SUBDIVISION COMMITTEE
METROPOLITAN AREA PLANNING COMMISSION

STAFF REPORT
(Preliminary Plat)

CASE NUMBER: S/D 88-99 - TIMBER RIDGE ADDITION

STAFF REPORT
(Final Plat; Preliminary Plat Approved 11/17/88)

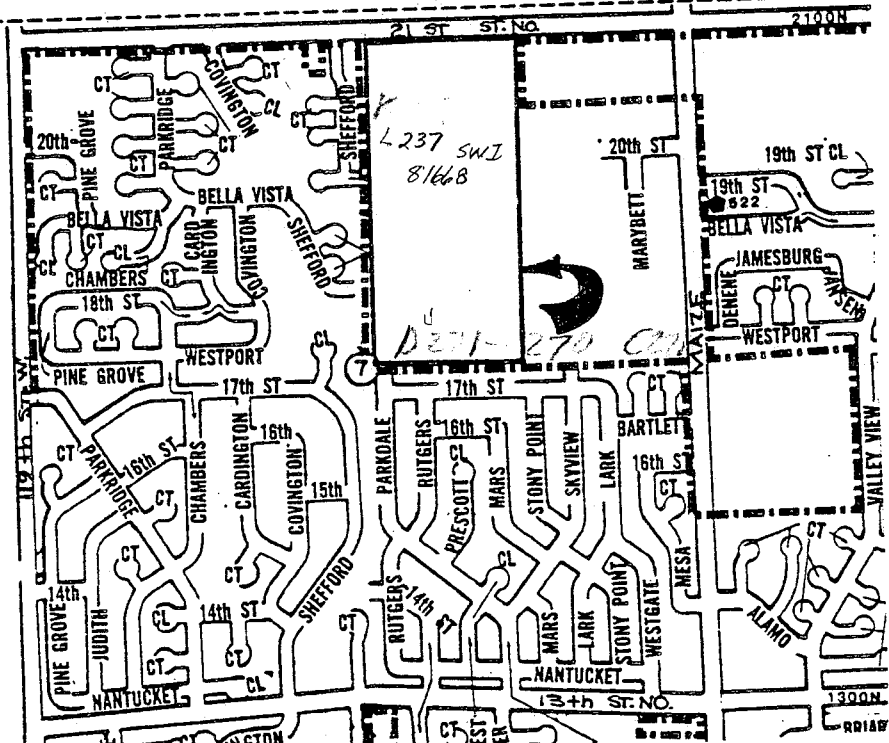
- A. The applicant shall guarantee the extension of City water to serve the lots being platted.
- B. The applicant shall guarantee the extension of sanitary sewer to serve the lots being platted.

- C. The applicant shall guarantee any drainage improvements required by the platting of this property.
- D. The applicant shall guarantee construction of the storm sewers required by this plat.

- E. The applicant shall guarantee the paving of the proposed interior streets.
- F. The Parkdale street paving petition shall provide for the construction of sidewalks on each side of this collector street. If the applicant chooses, he may propose an alternate sidewalk plan for this property rather than construct sidewalks on both sides of the collector street. If an alternate sidewalk plan is desired, the applicant shall submit 5 copies of the proposed plan prior to or at the time of submitting a final plat.

- G. The Shefford street paving petition shall provide for the construction of sidewalks on both sides of the street segment west of Parkdale or between Lot 1, Block 8 and Lot 17, Block 7. This segment of collector is a continuation of the collector in the Echo Hills 2nd Addition which has guaranteed sidewalks along Shefford.

- I. Except for the street entrances, the final plat shall indicate complete access control to 21st Street North across the north line of the plat. The wording in the plat's text regarding the dedication of access controls shall be worded so as to dedicate access controls to the appropriate governing body. Although this plat is within the City of Wichita, adjacent 21st Street North is within the unincorporated area of Sedgwick County.

- J. On the final plat, building setbacks shall be indicated for all lots. A 25-foot front yard setback, and 15-foot side yard setback for corner lots, shall be indicated.

- N. On the final plat, the 20-foot utility easements along the north line of the plat, adjacent to 21st Street North, shall be shown as full 20-foot wide easements up to the street right-of-way lines for the two streets entering off of 21st Street. These utility easements cannot be terminated by the apparent widening out of the wall easement in these areas.

- O. On the final plat, additional dimensions, and angles or bearings shall be indicated for the boundaries of the utility easements located in the reserves.

- P. On the final plat, dimensions shall be indicated for all lots.
- Q. Since the street segment indicated as Timber Ridge on the preliminary ends in a cul-de-sac it must use the suffix Court. In this case, the street segment could be named Cornelisan Court.

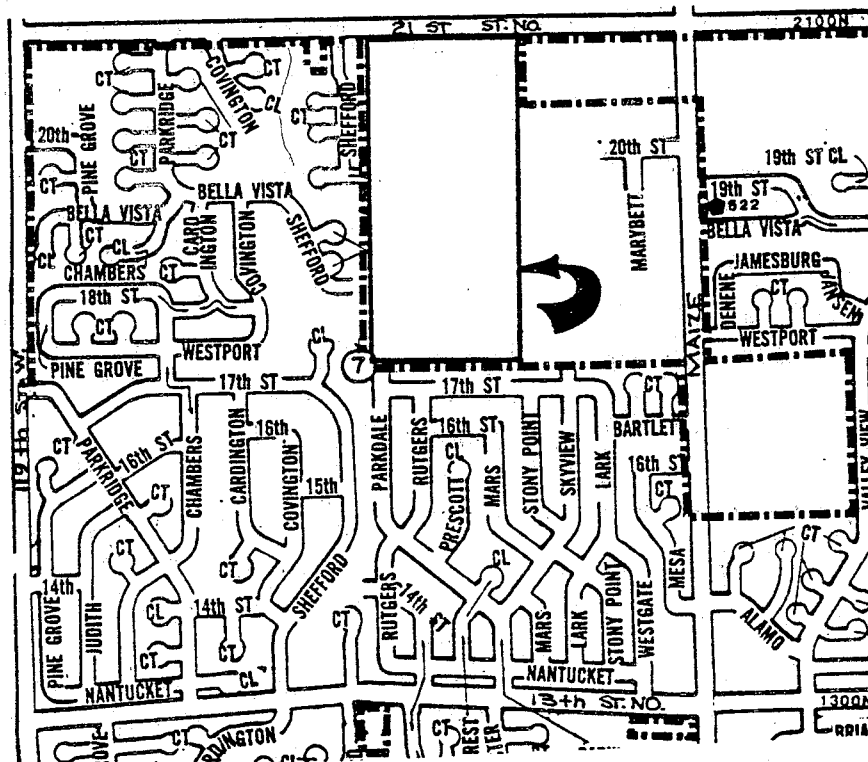
- M. When this plat was approved in its preliminary form it was determined that the 20-foot utility easement along the north line of this property should not terminate by the apparent widening of the wall easement at the two entrances to 21st street North. The final plat shows a triangle shaped wall easement causing the same concern, namely that a masonry wall and utility easement should not share the same area. Representatives from City Engineering and the utility companies should be prepared to comment on the acceptability of utilities running through this triangle wall easement.

- N. The plat's text shall indicate that in reserves A and B utilities are confined to easements.
- O. If the platting of this property requires the establishing of minimum building pad elevations, the elevations shall be noted on the face of the plat, as well as in the plat's text. Also, permanent on-site and off-site benchmarks shall be referenced on the face of the plat.

- U. Representative from the City Engineer's office should be prepared to comment on the status of the applicant's drainage plan. Specifically, are minimum building pads necessary and are any drainage guarantees required with the platting of this property.

- V. At the time of preliminary plat review, a requirement was made for the submitting of a sanitary sewer layout plan. The City Engineer's representative should be prepared to comment on the status of the applicant's sewer layout plan. Also, will sanitary sewer be within the 20-foot utility easement adjacent to 21st Street North?

- M. On the final plat tracing the triangular areas indicated as wall easements and adjacent to 21st Street North, shall be indicated as Reserves. The plattor's text shall note that utilities may cross these reserves and if sanitary sewer is involved at any of these locations, a hold harmless agreement shall also be submitted for each involved location.

- N. The plattor's text shall indicate that in reserves A and B utilities are confined to easements.
- O. If the platting of this property requires the establishing of minimum building pad elevations, the elevations shall be noted on the face of the plat, as well as in the plattor's text. Also, permanent on-site and off-site benchmarks shall be referenced on the face of the plat.
